OICA response:  
CA and CN comments on "hazardous  
condition" definition

27<sup>th</sup> IWG EVS

Tokyo 27-29 June 2023

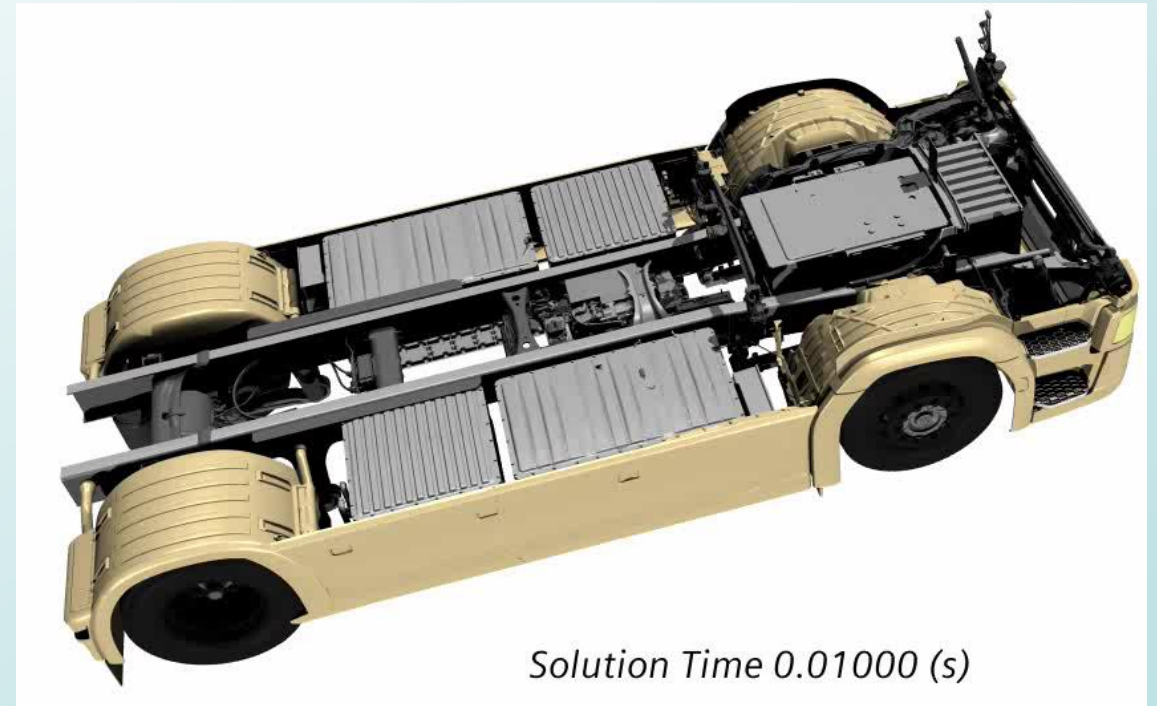
- If TP test is performed on vehicle level, evaluation of hazardous conditions from smoke shall be based on emissions inside the occupant cabin during the time for egress or 5 min
- If TP test is performed on component level, evaluation of hazardous condition from smoke should reflect conditions inside the vehicle cabin.
- Scaling of concentration of emissions inside the occupant cabin should be performed considering a relevant distance between the REESS and the cabin on the vehicle and the gas tightness of the cabin
  - Utilizing a single cabin tightness factor
  - Simulation of gas emission and flow patterns from the REESS

- Component level TP testing approach is feasible for passenger cars as well as heavy duty vehicles
- The principles of "family concept" are still applicable
  - Representative "severe case" for vehicles that are substantially similar with respect to vehicle platform and REESS type
  - Simulations are time consuming, resource demanding and costly to perform
